From: Yarnton Flood Defence <yarntonflooddefence@gmail.com>
Sent: 30 January 2023 20:29
To: Planning
Cc: Dave Woolley; Amy Evans; Phoebe Ryding; Yarnton Parish Council; David Thompson; Cllr Ian Middleton; Councillor Dorothy Walker; Will Savage; john.gloag@merton.ox.ac.uk; Vidovic, Andrew - Oxfordshire County Council; Bawar, Nagina - Oxfordshire County Council; Tony Brummell; Dave Stickland; Karen Nelson; Ana Pereira; David Stamateris; James Hern; keith.johnston@yarnton-pc.org.uk; Yarnton Parish council; Jackie Hoyle
Subject: Re: Planning application 21/03522/OUT OBJECTION to FINAL FLOOD STRATEGY

Re: Planning application 21/03522/OUT

OBJECTION to FINAL FLOOD STRATEGY submitted by PJA.CO.UK dated December 2022 on behalf of Merton College

Figure 5-5: Modelled 1 in 20-year Baseline Flood Depths – Woodstock Road

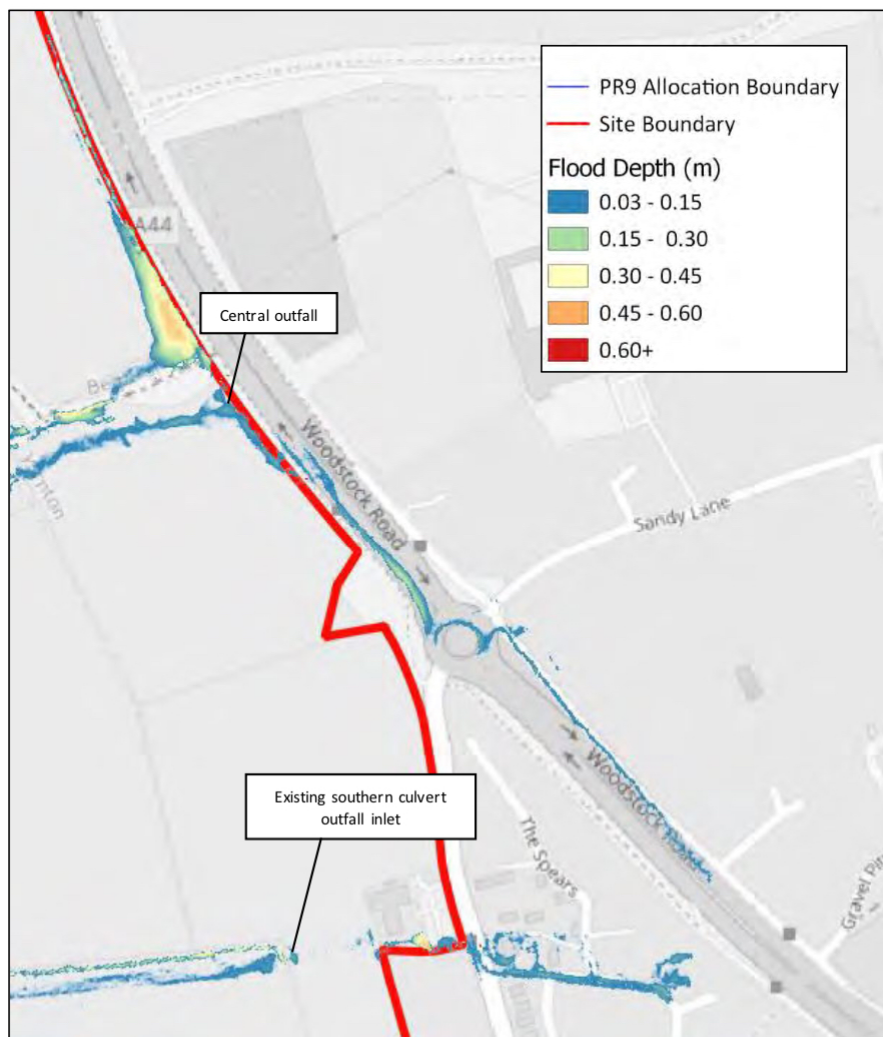
The sets of drawings included in the report show similar predicted outlines for change in off-site water depths in Aysgarth Rd for all flood events – from a green field up to the 1 in 1000 return period. The

similarity suggests there is limited real data available outside the site limits on which to base reliable risk estimates. Certainly the drawings all show, what could be seen, as an attenuation pond sitting in the highway in Aysgarth Rd and having no overground exceedance route onto the A44, Woodstock Rd. The pond only being drained by a third party pipe of uncertain ownership. If the pipe were to become blocked what would be the maximum extent of the pond outline and who would be at risk?

Figure 6-3 – Spot Height Data (1m DTM LiDAR)

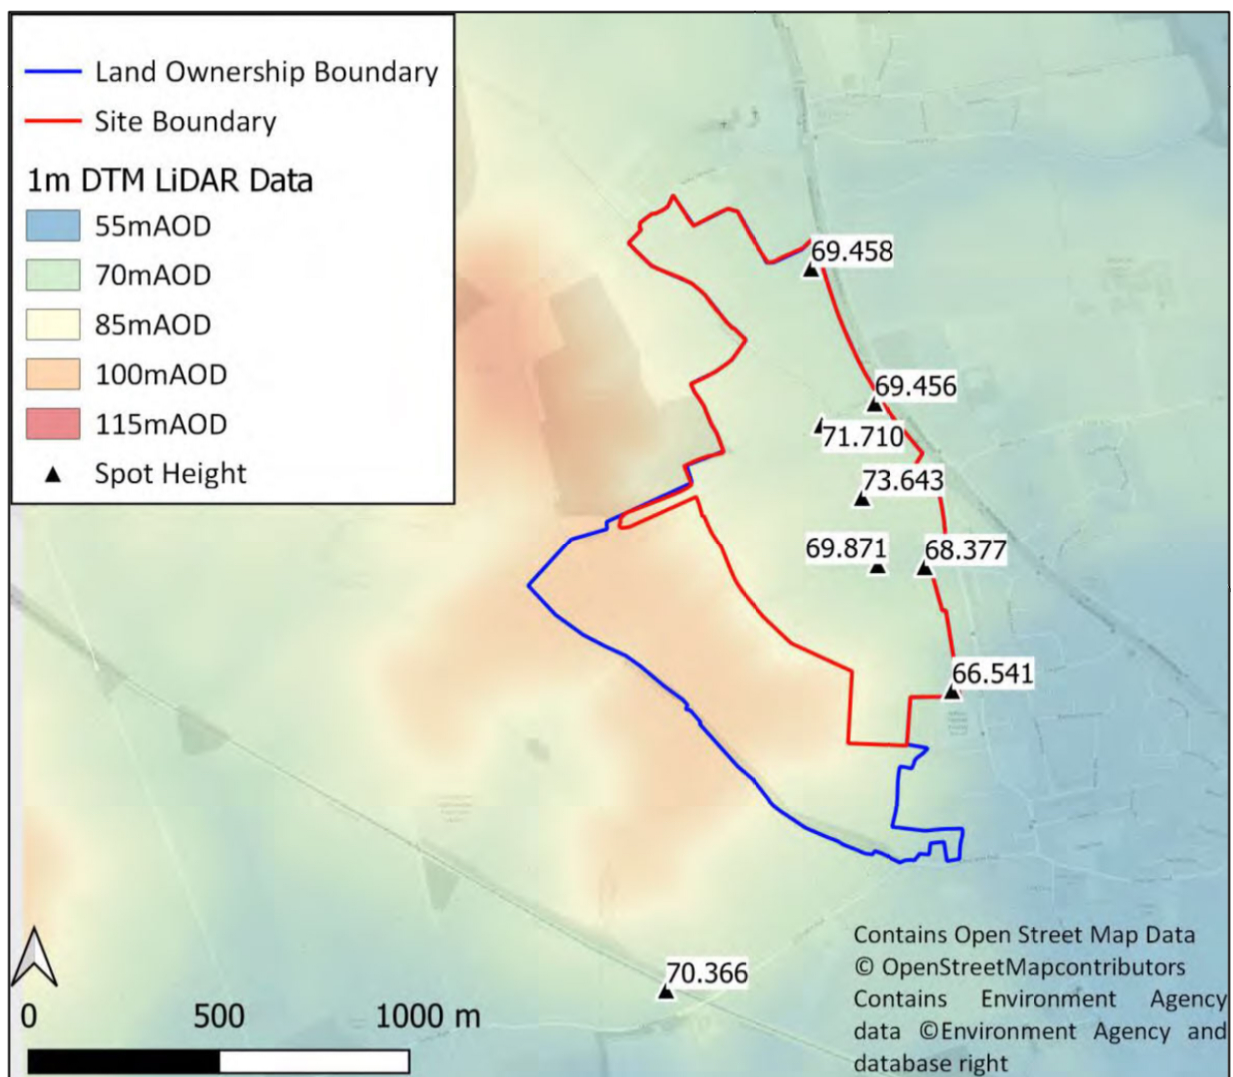
PJA have used the publicly available one meter LIDAR data and produced a smoothed model of the terrain. (Figure 6.3 attached) They have used Manning's N factors for rural and urban land to calculate runoff figures to argue that there is a benefit in a change from a rural to urban catchment. They go on to argue that due to its rudimentary nature, the model does not account for finer grain undulations that could retain and further attenuate the surface water flows. And similarly, with the masked features such as ditches and culverts. All this may, they argue, provide a reduction in the level of flood risk in the village. However, as far as we can tell from the information they have released the surface model also relies on the rate of surface water extraction at the existing southern and central culvert inlet nodes. The extraction rate is calculated using the well established Colebrook equation to determine a maximum pipe discharge rate based simply on an unobstructed pipe diameter and material roughness. They have not stated what confounder values they have used for head losses throughout the culvert length for changes in pipe direction, the connection of other joining pipe flows in manholes, intrusions into the culvert by badly made gully connections, utility-crossings through the culvert, intruding roots and groundwater infiltration. In short, the rate of pipe-flow is likely to be much less than that calculated using the Colebrook equation. To date they have not ventured to explain the discrepancies between their theoretical outputs and the photographic flooding evidence YFD has provided. However, they have acknowledged that the existing surface water systems does surcharge, which to us is a clear indication of insufficient capacity to serve the existing village and the proposed site.
